W. M. JORDAN COMPANY'S ADDENDUM No. 1

PROJECT: THE WILMINGTON FOOD BANK CD SET

DATE: 12/2/21

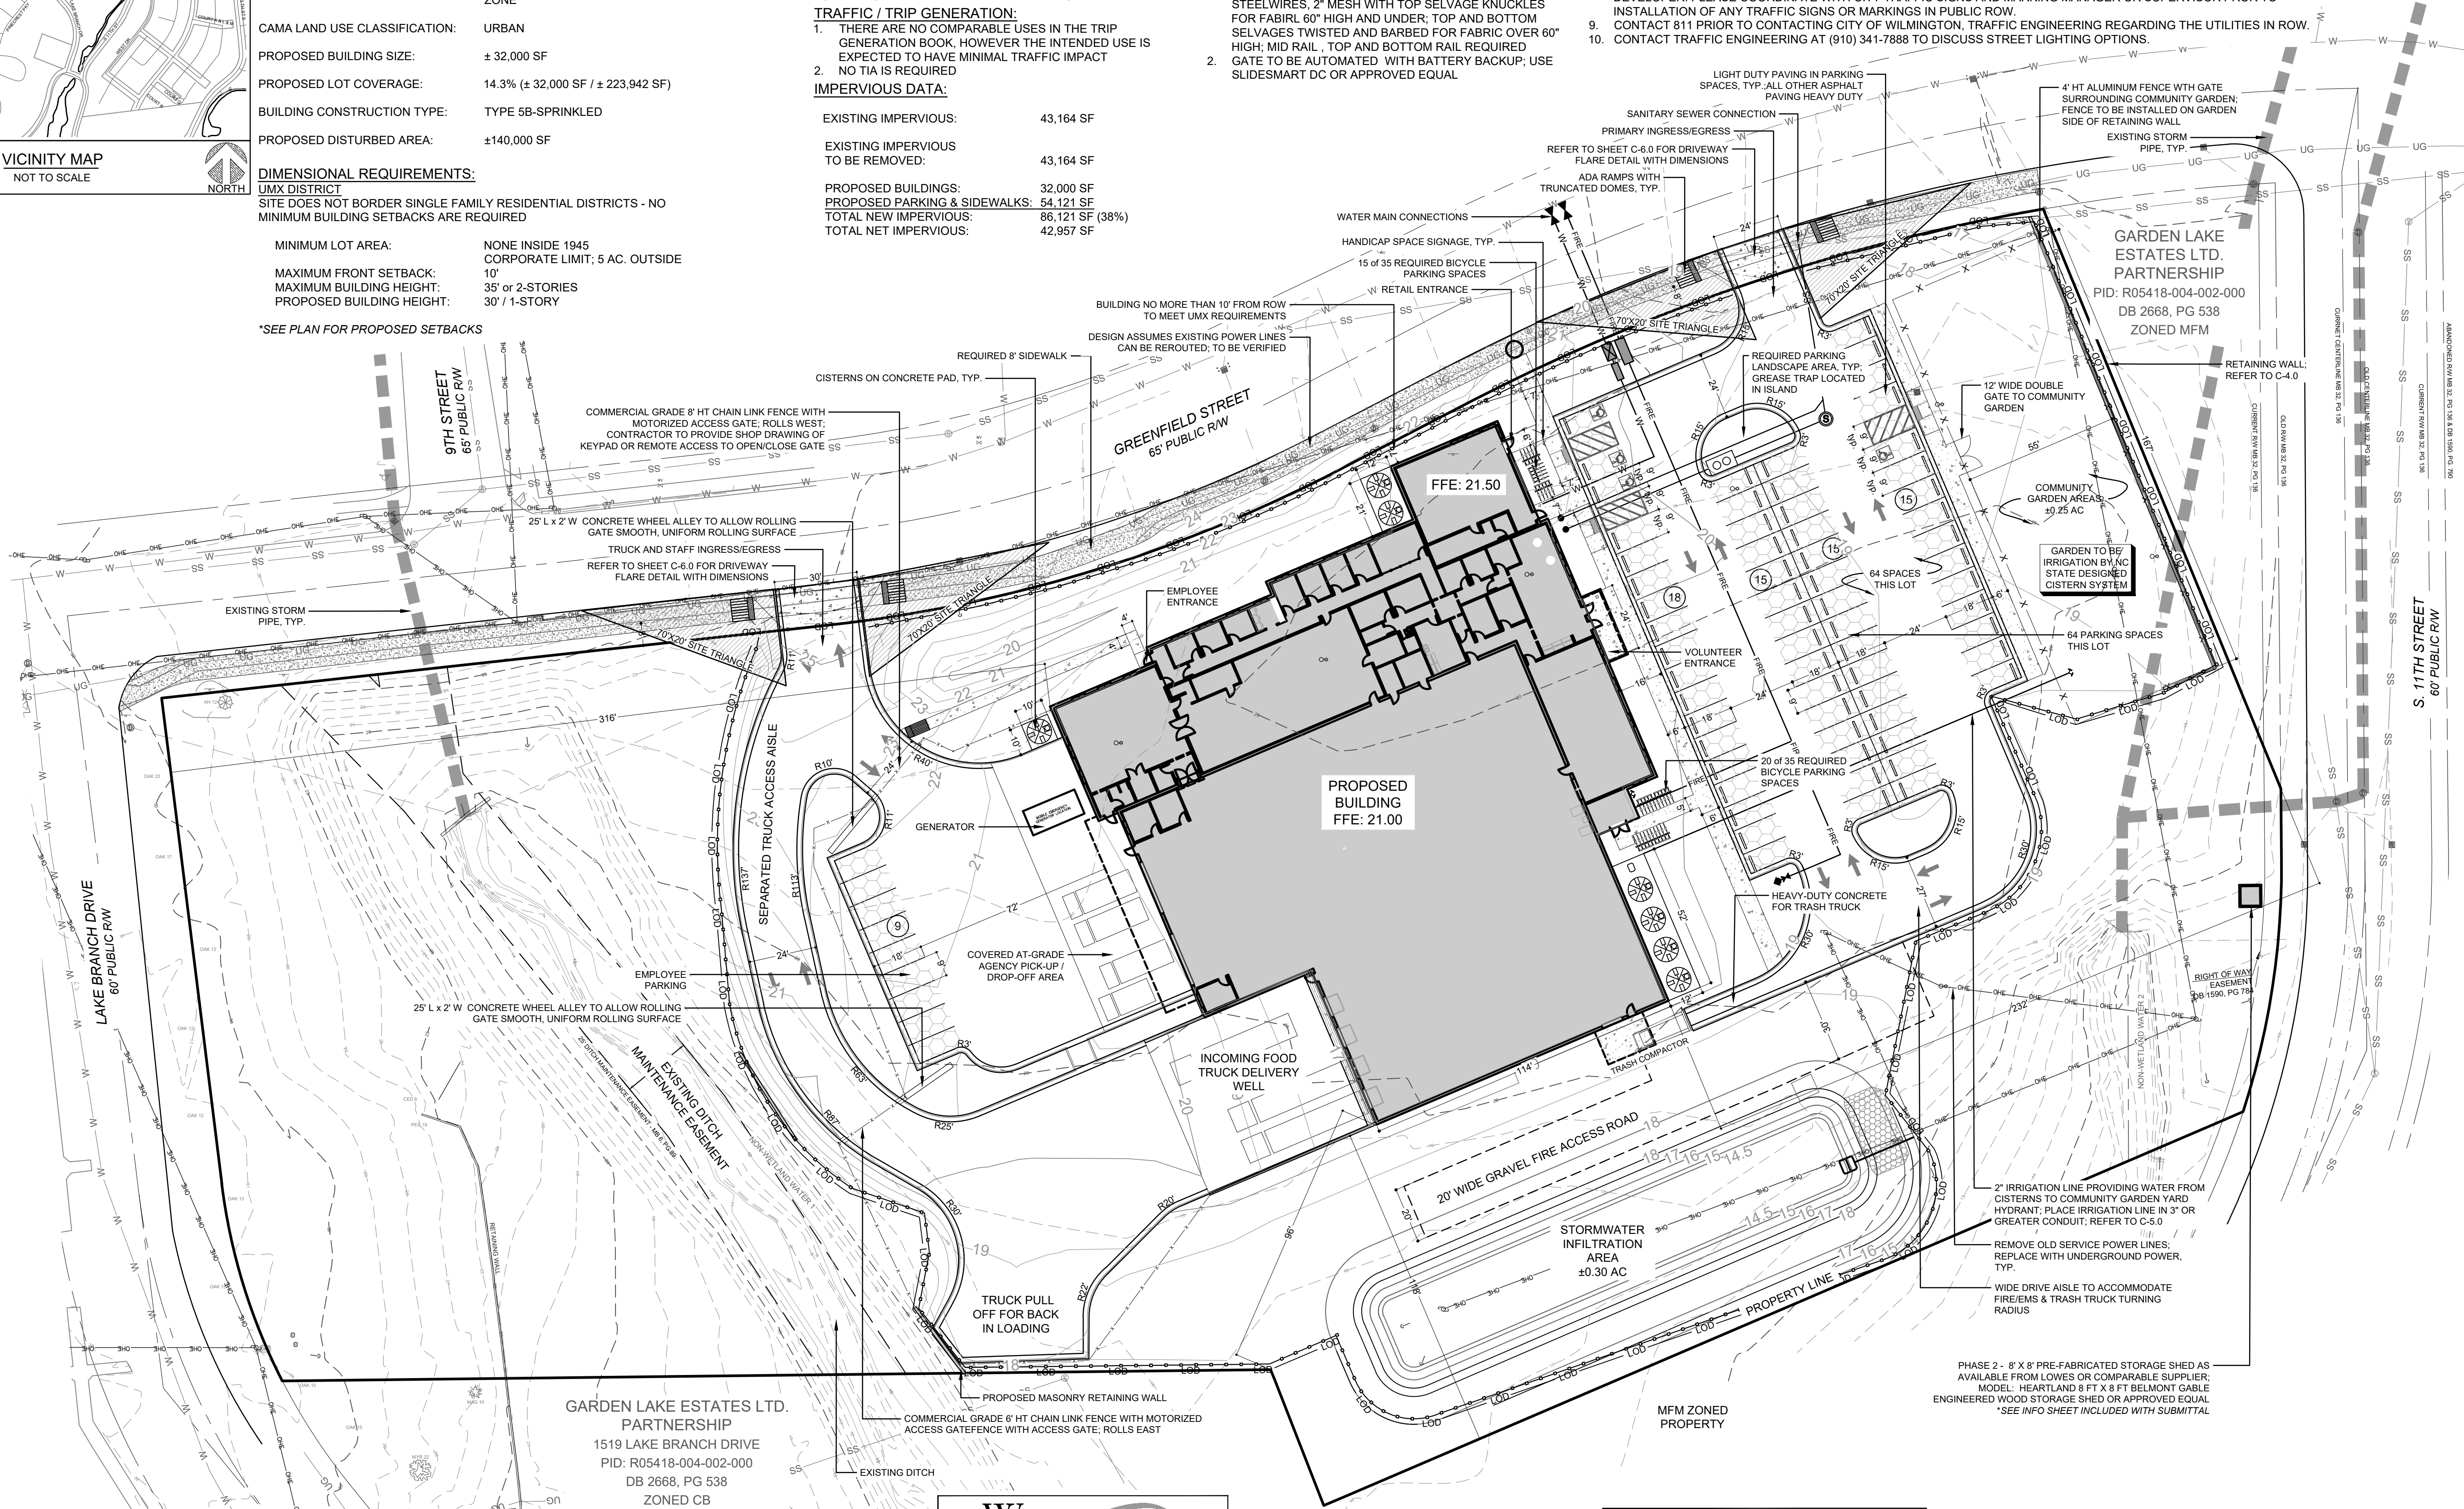
24. Question: Sheet C-2.0 shows site fencings around truck access and Agency Pick-up as 6' high while A0.1 shows 8'. Please advise which is correct.

Answer: Sheet C-2.0 is incorrect. The fence around truck access and Agency Pick-up is 8'
